Subject: Transmittal of Revision 3 to Service Bulletin Number

V2500-ENG-72-0122

ENGINE - HP TURBINE ROTOR AND STATOR ASSEMBLY - PROVIDE NEW STAGE 2 HPT VANE ASSEMBLIES, STAGE 2 AIR SEALING RING SEGMENT ASSEMBLIES AND STAGE 2 HPT SEALS

Location of The Turbine Case And Vane Assembly And The Stage 2 HPT Ring Segment And Vane Cluster Assembly Figure 1 (Sheet 1)

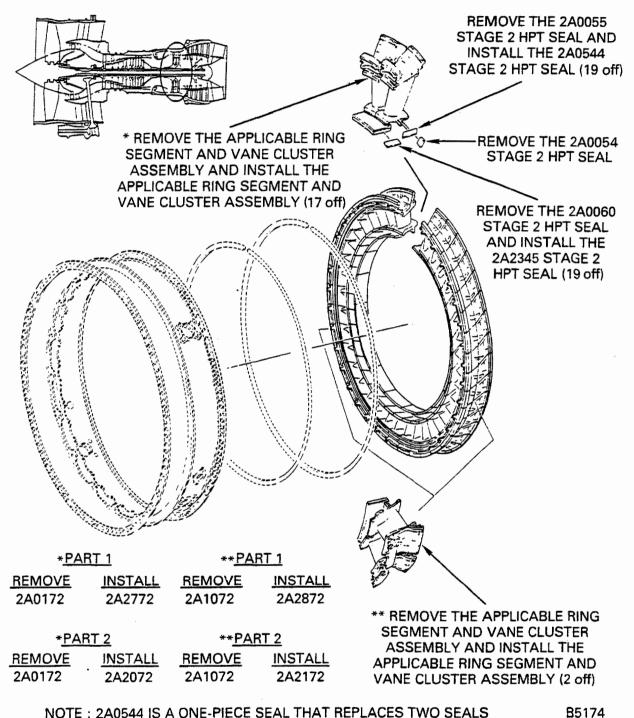
REMOVE	INSTALL
2A1357	2A2445
2A1764	2A2446

REMOVE	INSTALL
2A1357	2A1718
2A1764	2A2188

Location of The Turbine Case And Vane Assembly And The Stage 2 HPT Ring Segment And Vane Cluster Assembly Figure 1 (Sheet 2)

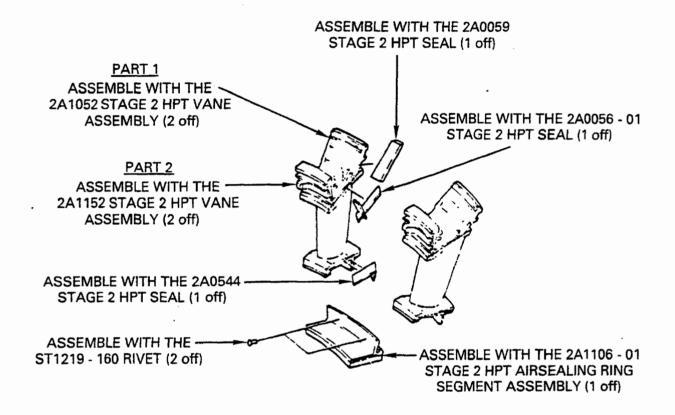
NOTE: 2A0544 IS A ONE-PIECE SEAL THAT REPLACES TWO SEALS

Location of The Turbine Case And Vane Assembly And The Stage 2 HPT Ring Segment And Vane Cluster Assembly Figure 1 (Sheet 3)

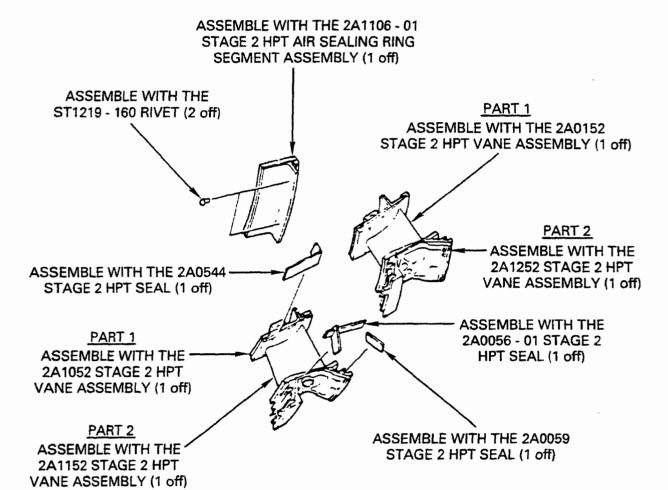
2A2772 (Part 1) OR 2A2072 (Part 2) STAGE 2 HPT RING SEGMENT AND VANE CLUSTER ASSEMBLY (17 off)

Family tree - Stage 2 Ring Segment And Vane Cluster Assembly Figure 5

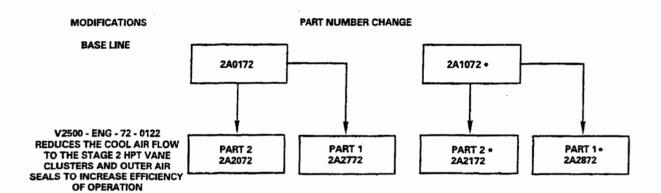
A NEW ONE PIECE STAGE 2 HPT SEAL (Featherseal)
A NEW LONGER STAGE 2 HPT AIR SEALING RING SEGMENT ASSEMBLY AND SEAL (Featherseal)

A NEW ONE PIECE STAGE 2 HPT SEAL (Featherseal)
A NEW LONGER STAGE 2 HPT AIR SEALING RING SEGMENT ASSEMBLY AND SEAL (Featherseal)
A NEW STAGE 2 VANE COVER WITH A DIRECTIONAL FLOW CAVITY
A NEW SMALLER METERING HOLE IN THE REAR OUTER LEG OF THE VANE
